Manuscript AIS 3400076: revision workbook

Every editor and reviewer comment, exact edits in LaTeX, and the response letter

Built from the decision letter (22 Sep 2026), the submitted manuscript and SI, the repository code and the original datasets.

1.3 Figure 3

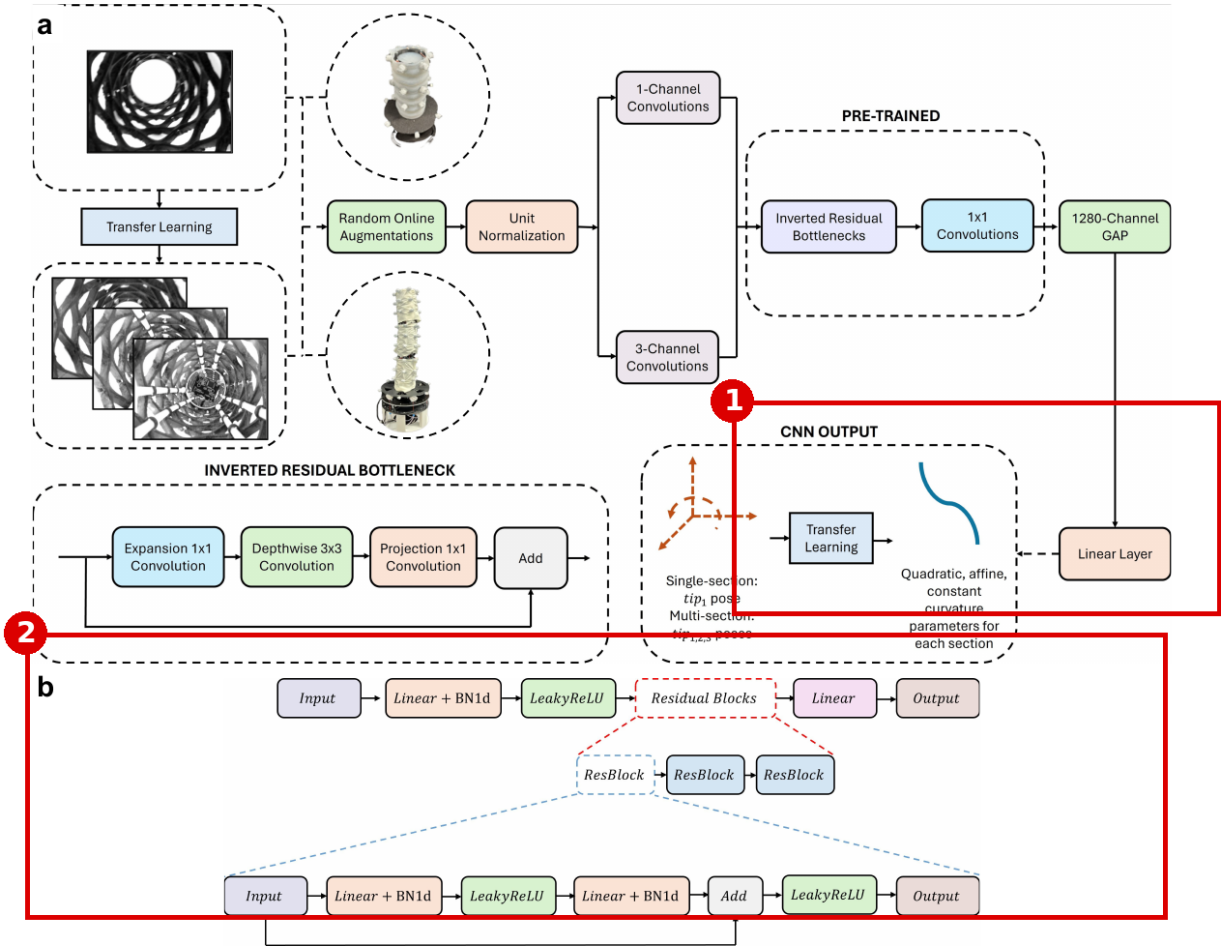
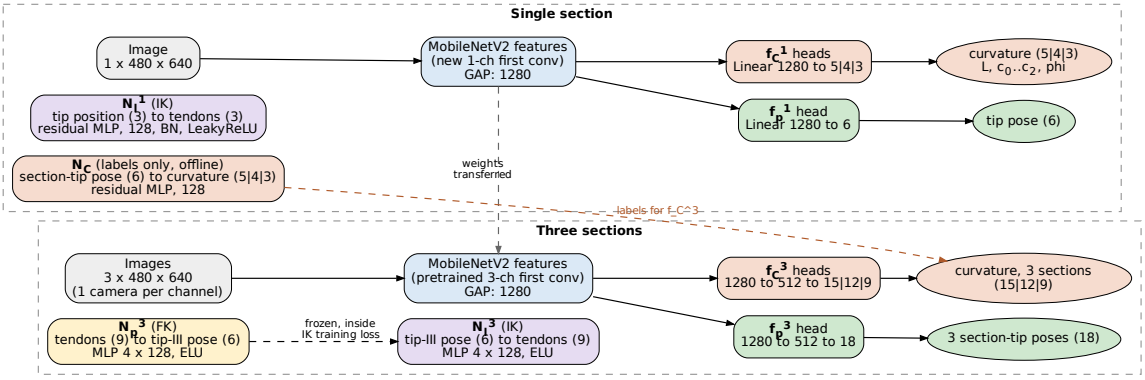
Several figures—particularly Figs. 1B, 2, 3, and 5—are difficult to interpret. [...] In particular, Figure 3 requires attention. [...] The paper should use a consistent flow direction, label all network inputs and outputs, and distinguish clearly between the networks used for pose estimation, curvature reconstruction, forward kinematics, and inverse kinematics.

Step 3 Manuscript, Fig. 3: redraw (explicitly requested).

Keep the two panels and their content, and change:

1. One flow direction, left to right, in both panels.
2. The network name on each output path: f_p^1, f_C^1 (single), f_p^3, f_C^3 (multi) in panel a; N_l^1 and N_C on panel b.
3. Sizes: input $n \times 480 \times 640$; GAP output 1280; heads "1280 $\to$ 6" and "1280 $\to$ 5|4|3" ($n = 1$), "1280 $\to$ 512 $\to$ 18" and "1280 $\to$ 512 $\to$ 15|12|9" ($n = 3$). Marker ①: the single box "Linear Layer" is wrong for $n = 3$, whose heads have two layers.
4. One color per role: pose (green), curvature (orange), forward kinematics (yellow), inverse kinematics (purple).
5. Panel b (marker ②) is the residual MLP of N_l^1 and N_C. Add a small box next to it: "N_p^3: 9 $\to$ 4 $\times$ 128 ELU $\to$ 6; N_l^3: 6 $\to$ 4 $\times$ 128 ELU $\to$ 9, trained through the frozen N_p^3".

Step 4 **Manuscript, Fig. 3: replace the whole caption.**

position, 3 $\to$ tendon lengths, 3) and $N_C$ (section-tip pose, 6 $\to$ curvature parameters of the section).
The input vector is projected into a 128-dimensional latent space and processed through three residual blocks,
each comprising two fully connected layers with Batch Normalization and LeakyReLU activations, followed by the
output regression head. The multi-section kinematic networks $N_p^3$ (tendon lengths, 9 $\to$ tip pose, 6) and
$N_l^3$ (tip pose, 6 $\to$ tendon lengths, 9) are MLPs with four hidden layers of 128 units and ELU activations;
$N_l^3$ is trained through the frozen $N_p^3$ (Eq.~11).}
```

1.4 Figure 4

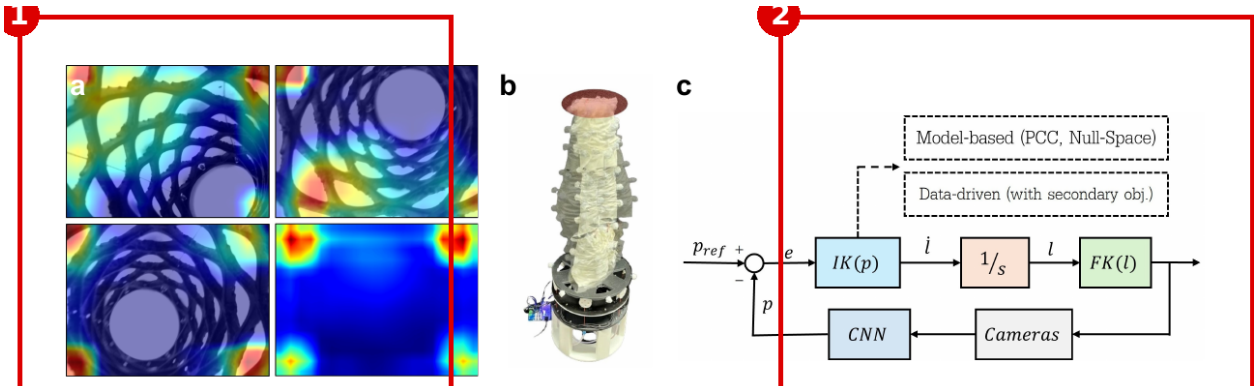
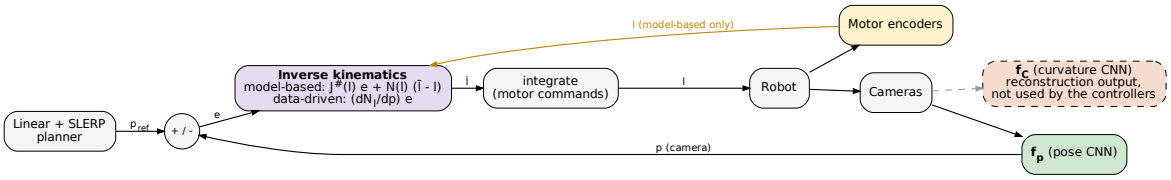
The abstract, contribution list, Fig. 4c, and conclusion should clearly distinguish: camera-based pose estimation used for control; encoder measurements used to calculate the Jacobian and null-space term; and image-based PPC reconstruction evaluated as a separate sensing capability. [. . .] clarify how the highlighted pixels are the regions used for prediction.

Step 5 **Manuscript, Fig. 4c: add one block and one arrow (marker ②).**

Add a block “Encoders” that reads $\mathbf{l}$ (the output of the $1/s$ block). Draw an arrow from it to the box “Model-based (PCC, Null-Space)” and label it “$\mathbf{l}$ (model-based only)”. Optionally, add a dashed block “f_C (curvature CNN): reconstruction output, not in the loop”, fed by “Cameras”. Sketch:

```
\caption{(a) Grad-CAM visualizations from $f_p^1$ for different bending configurations and average Grad-CAM over
the test set. Colors show the heatmap of Eq.~S12, normalized to $[0, 1]$ per image and displayed without
thresholding; warm colors mark the regions whose activation most reduces the prediction loss. The network mostly
focuses on deformations of the Trimmed Helicoid structure along the bending direction. (b) Different null-space
configurations yield the same tip pose. (c) High-level kinematic closed-loop controller. The tip pose estimated
by the pose CNN from the camera images is the feedback signal of both controllers. In the model-based controller,
the motor encoders provide the tendon lengths used by the PCC Jacobian and the null-space term; the data-driven
controller does not use encoders. The curvature CNNs are not part of the control loop.}
```

1.5 Figure 5

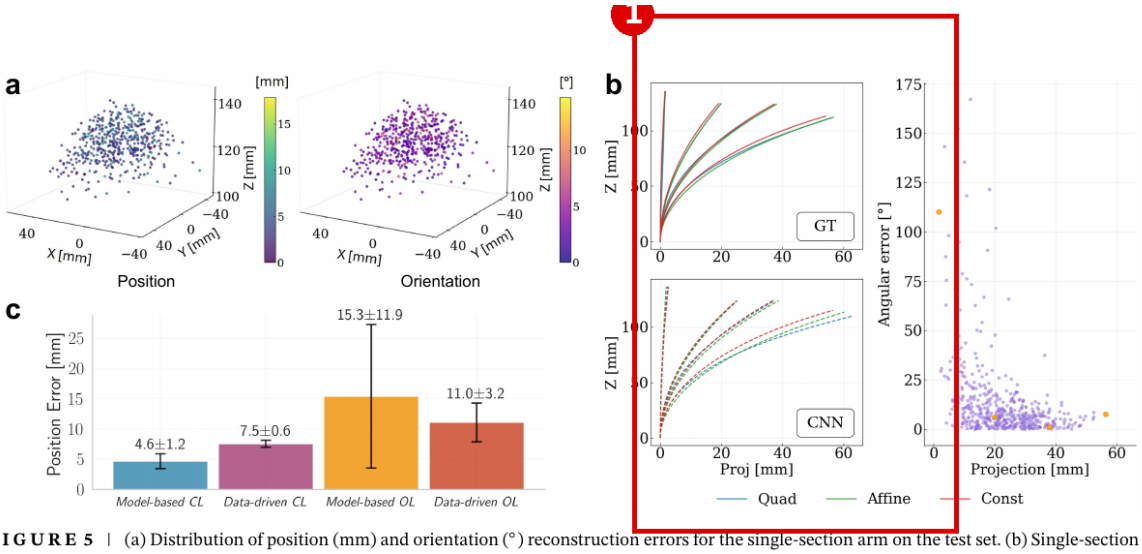
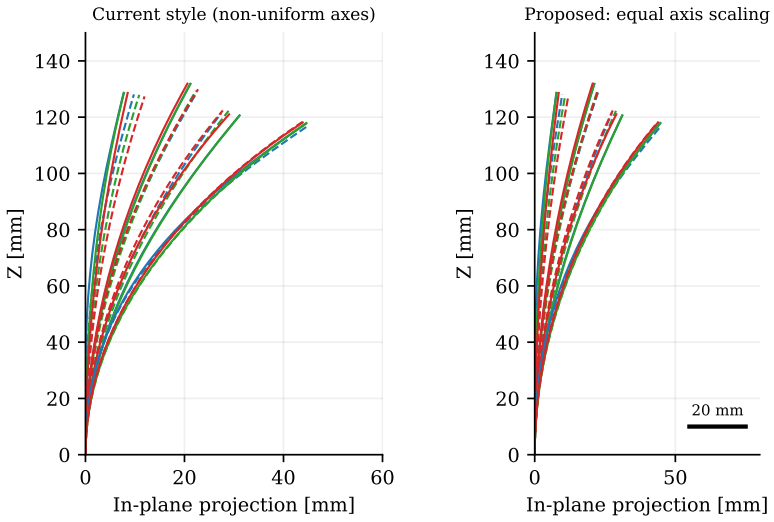
Figure 5b intentionally uses nonuniform axis scaling. This visually distorts the reconstructed shapes. Use equal spatial scaling where possible or add a second undistorted view and explicit scale bars.

Step 7 Manuscript, Fig. 5b: equal axis scaling (marker ①).

In the plotting code of the two shape panels (GT and CNN), set `ax.set_aspect('equal')` and give both panels the same limits (e.g. x 0–60 mm, z 0–150 mm). Equal axes make the panels narrow, so the simplest layout is one panel with GT (solid) and CNN (dashed) overlaid. The right panel below shows this layout, produced from the same models (`SINGLE/results/fig5b_equal_axes.pdf`, from `SINGLE_revision_figures.ipynb`):

```
\caption{(a) Distribution of position (mm) and orientation ($^\circ$) reconstruction errors for the
single-section arm on the test set. (b) Single-section curvature reconstruction and bending angle error. Four
test examples with increasing deformation are shown, with GT (ground-truth) reconstructions as solid and CNN
predictions as dashed lines. Axes have equal scaling. The corresponding $\phi$ angular errors are highlighted in
orange. (c) Performance of the proposed controllers on the control workspace of the single-section arm (CL:
closed-loop; OL: open-loop). Bars show the mean final position error over the 20 targets; error bars show one
standard deviation across targets, each visited once.}
```

1.6 Figures 6, 9 and 10

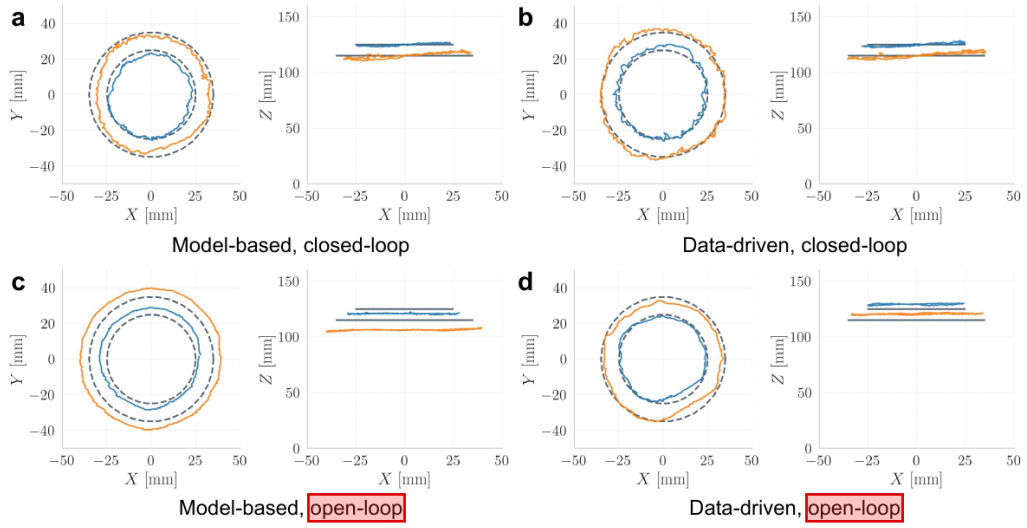
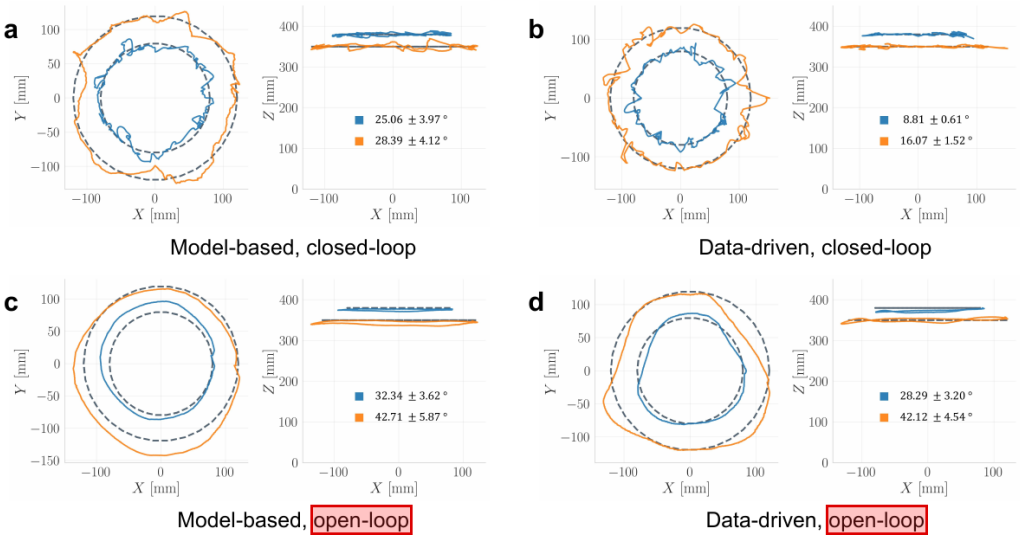
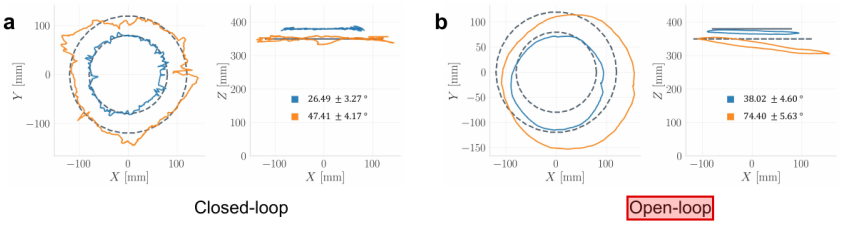
'Open-loop' and 'feedforward' should be used consistently. [. . .] For Figs. 6, 9, and 10, identify the start direction, waypoint order, number of completed cycles, and whether the plotted paths are one run or an average. Add quantitative path errors in the caption or an accompanying table.

```
\begin{table}[h]
\centering
\caption{Path errors of the trajectory-tracking experiments (Figs.~6, 9 and 10). Radial RMS: root-mean-square distance of the executed path from the reference circle, measured in the horizontal plane; height RMS: root-mean-square of $z - z_{\mathrm{ref}}$. The reference circle is the commanded one (center and radius of the commanded waypoints). Each row is a single run of one cycle; consecutive samples along a path are serially correlated and are not independent trials.}
\label{tab:S7_paths}
\begin{tabular}{lllrrr}
\toprule
Arm & Controller & Loop & $z_{\mathrm{ref}}$ [mm] & Radial RMS [mm] & Height RMS [mm] \\
\midrule
Single & Model-based & closed & 115 & 1.46 & 2.65 \\
Single & Model-based & closed & 125 & 1.32 & 1.23 \\
Single & Data-driven & closed & 115 & 1.71 & 2.49 \\
Single & Data-driven & closed & 125 & 1.83 & 1.54 \\
Single & Model-based & open & 115 & 8.06 & 8.74 \\

1.7 Figure 7

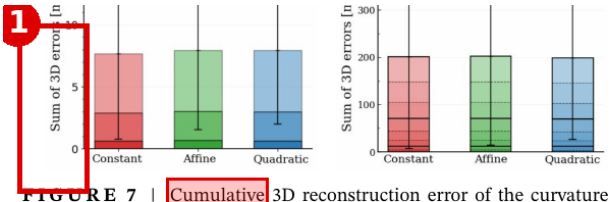
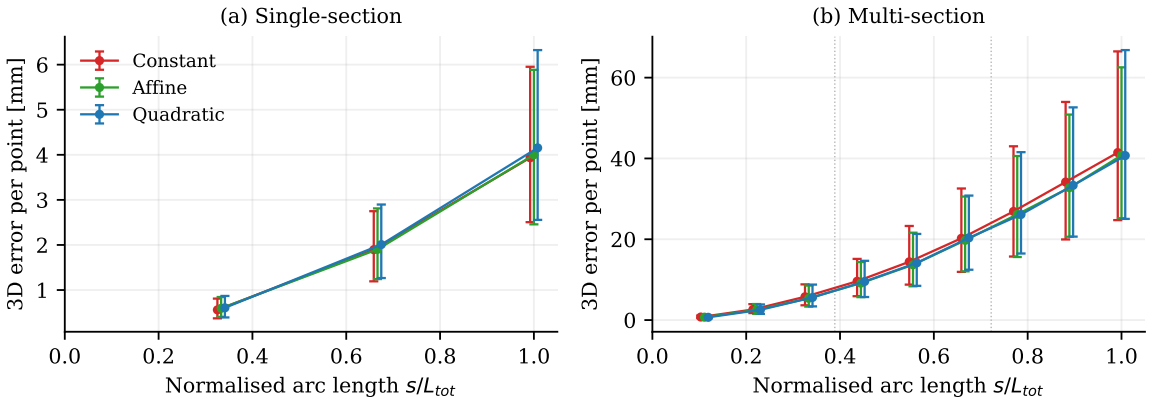
Figure 7 alternates among 'cumulative 3D error,' 'sum of 3D errors,' and 'average 3D error for each point.' Define the statistic exactly. Summing three points for the single-section arm and nine for the multi-section arm also prevents direct comparison. Per-point RMSE or error versus normalized arc length would be clearer.

Step 11 **Manuscript, Fig. 7: replace the graphic with the per-point version.**

The new version uses the same models and the same test set. The bar heights of the current figure (7.8, 7.9, 8.3 mm and 209, 203, 198 mm) are the sums of the per-point means shown here. Use `MULTI/results/fig7_per_point.pdf` (from `MULTI_revision_figures.ipynb`) as is, or replot it in your style (median and interquartile range against s/L_{tot}):

```
\caption{3D reconstruction error of the curvature models along the backbone. For each test sample ($N = 500$),
the backbone reconstructed from the predicted curvature parameters is compared with the one reconstructed from
the curvature labels, and the 3D distance is evaluated at each reference point. (a) Single-section arm: reference
points at $L/3$, $2L/3$, and $L$. (b) Multi-section arm: reference points every ninth of the arm length; the
labels are model-constrained (Section~2.2). The horizontal axis is the arc length normalized by the total length;
markers show the median and error bars the interquartile range.}
```

1.10 Figure S2

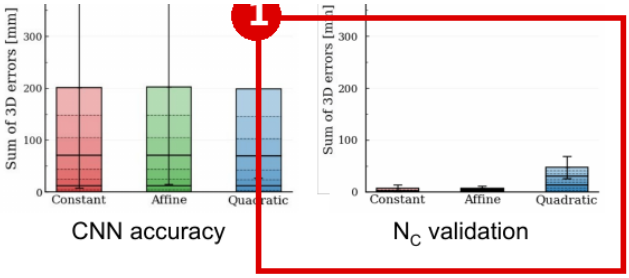
Fig. S2b does not provide sufficient validation of N_C: numerical errors, sample count, data split, and confidence intervals are missing. It is also unclear whether its validation configurations are independent of the data used to train N_C and the three-section curvature estimator. [. . .] Fig. S2b should report the numerical N_C error for each curvature model, the number of validation configurations, and whether the bars show standard deviation, standard error, or another interval.

```
\caption{(a) 3D reconstruction accuracy of the curvature models at reference points placed every ninth of the
manipulator length: sum over the nine points of the mean error at each point (same data as Fig.~7b). (b) Errors
induced by the $N_C$ approximation with respect to the motion-capture ground truth, on 20 configurations of the
multi-section arm posed manually with all subsection markers visible and recorded in a separate session; these
configurations were not used to train $N_C$ or the multi-section curvature CNNs. Bars show the sum over the nine
reference points of the mean 3D error at each point; error bars show one standard deviation of the
per-configuration sum across the 20 configurations.}
```

1.11 Figure S3

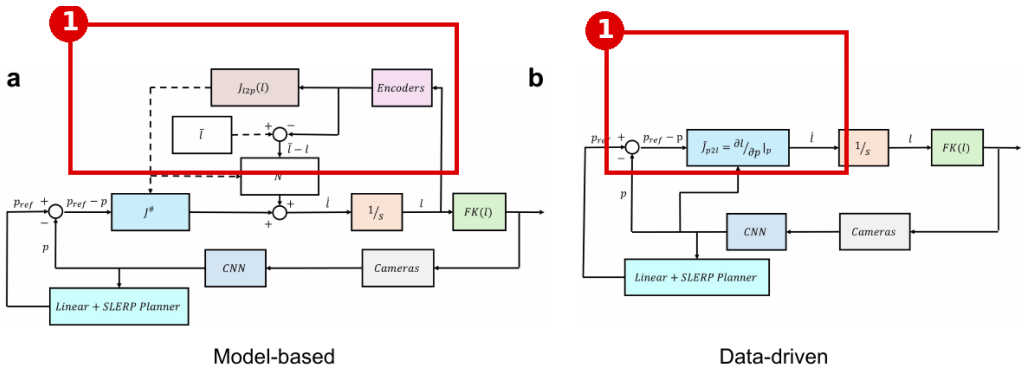
Step 18 SI, Fig. S3: change the symbols in the blocks (marker ①).

Model-based panel: the Jacobian block becomes $\mathbf{J}^{\#}$ of $\mathbf{J}_{l\to p}(\mathbf{l})$. Data-driven panel: $\hat{\mathbf{J}}_{p\to l}$. This is the notation of Section 3.3. Caption unchanged.

1.12 Figures S4–S6

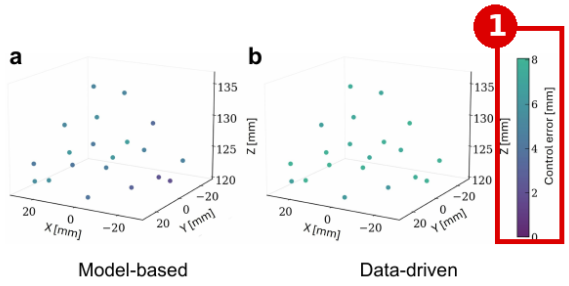
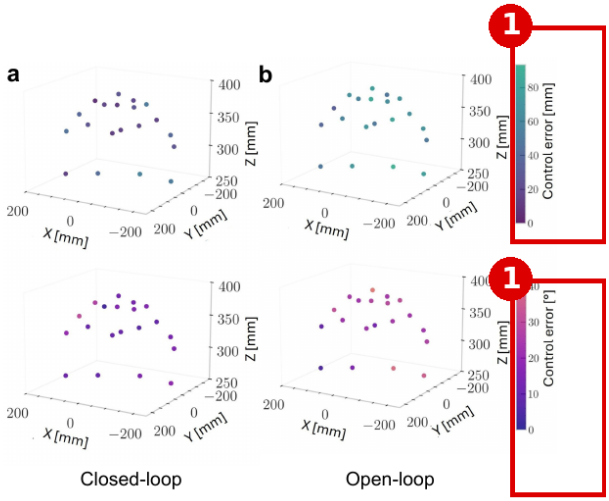
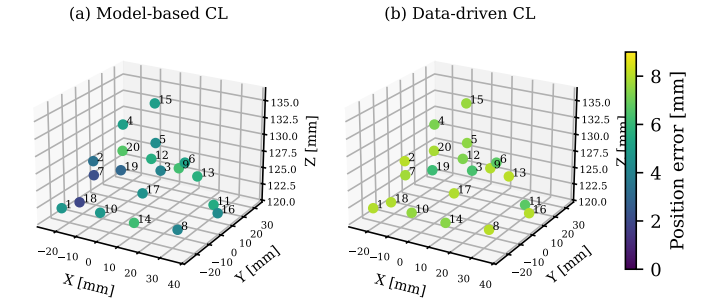
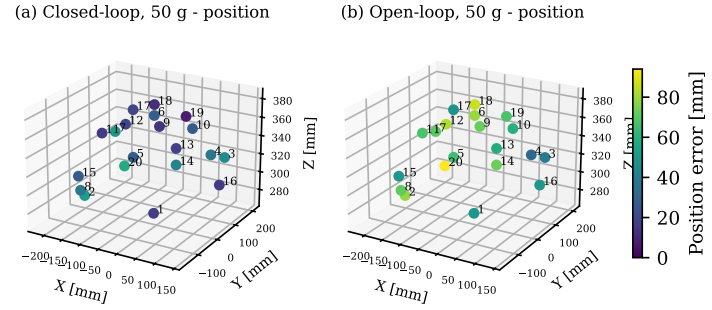
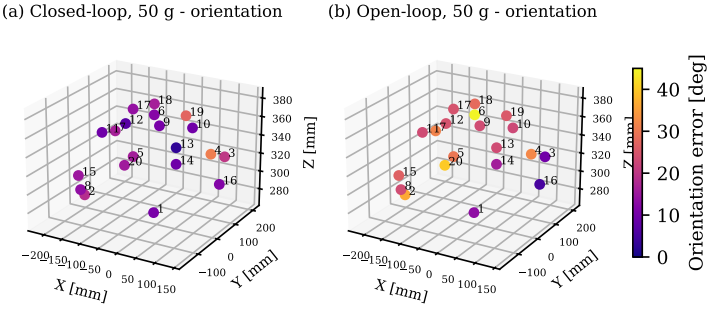
Figs. S4–S6 should use matched target identifiers or connecting pairs so the reader can compare the same workspace locations across controllers. Use consistent color limits when the goal is direct visual comparison.

Same data and plots, with two changes:

- Each target carries its ID (1–20, the same as in Tables S8 and S9).
- Each figure uses one color scale per quantity; marker ① shows the current independent color bars.

```
\caption{Closed-loop tracking error distribution (mm) on the control workspace for the single-section arm. (a) Model-based. (b) Data-driven. Numbers identify the targets (Table~S8); both panels share the same color scale.}
```

```
\caption{Closed-loop tracking error distribution (mm and $^\circ$) on the control workspace for the multi-section arm. (a) Model-based. (b) Data-driven. Numbers identify the targets (Table~S9); panels showing the same quantity share the same color scale.}
```

```
\caption{Tracking error distribution (mm and $^\circ$) for the multi-section arm under external disturbance (50~g tip payload). (a) Closed-loop. (b) Open-loop. Numbers identify the targets (Table~S9); panels showing the same quantity share the same color scale.}
```
